Amendment No. 0005  
28 March 2003

SUBJECT: Amendment No. 0005 to specifications and drawings for Construction of  
SBIRS SCIF - BUILDING 430, CRWU 02-1001, BUCKLEY AFB, COLORADO.  
Solicitation No. DACA45 03 R 0001.

SK Δ1.03  
Am #0005

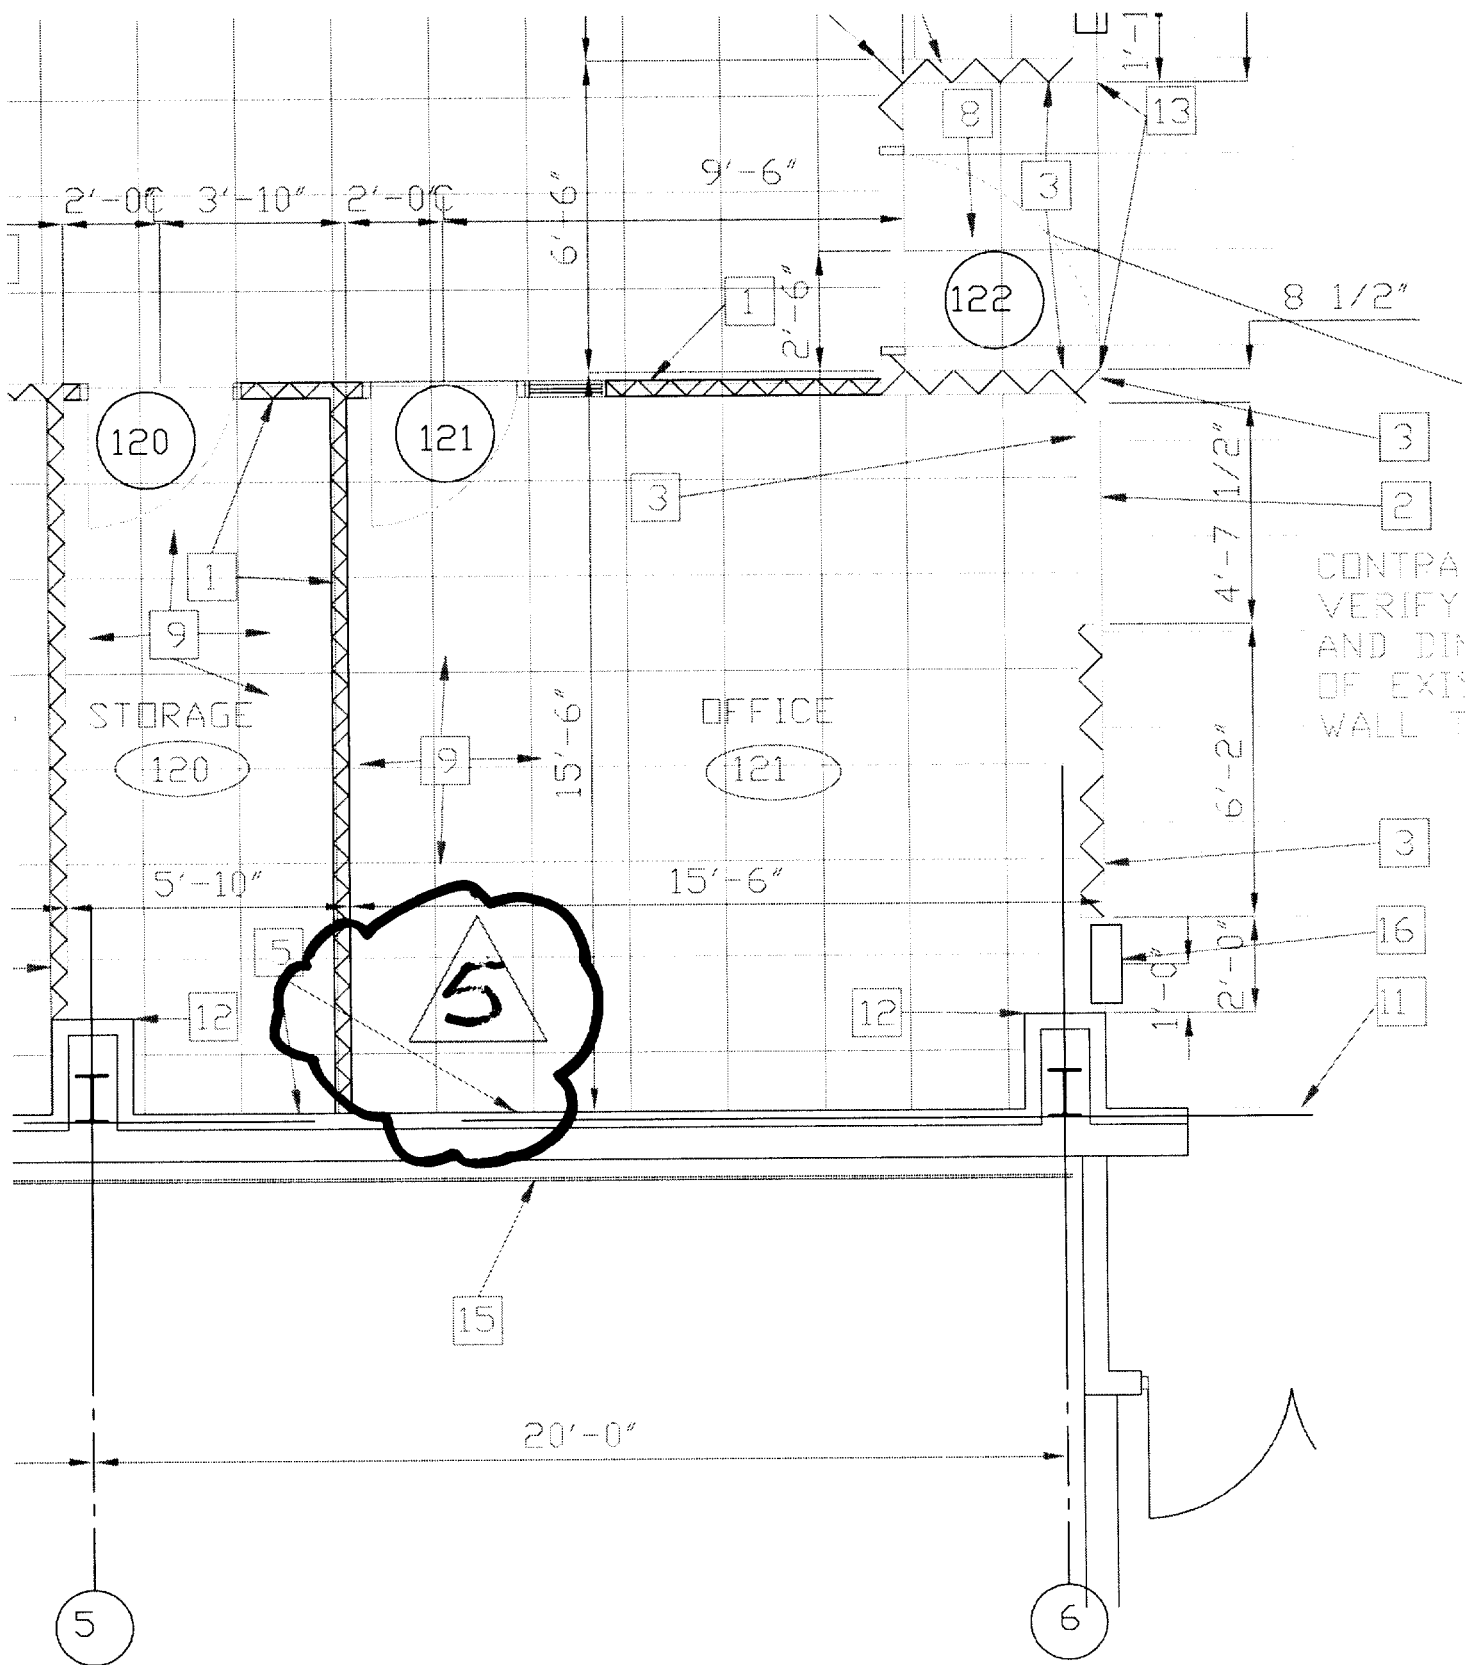
- (a) KEYED NOTES, note 2.
  - i) Line 2, delete "ROOM 104 SIDE" and substitute "ROOM SIDE".
  - ii) Last line, delete "TYPE 4" and substitute "TYPES 4 & 5".
- (b) KEYED NOTES, note 5, line 5, after "PROVIDE ANY ADDITIONAL", insert: "GWB,".
- (c) FLOOR PLAN - AREA B, revise floor plan in accordance

with attached Sketch SKA1.03.
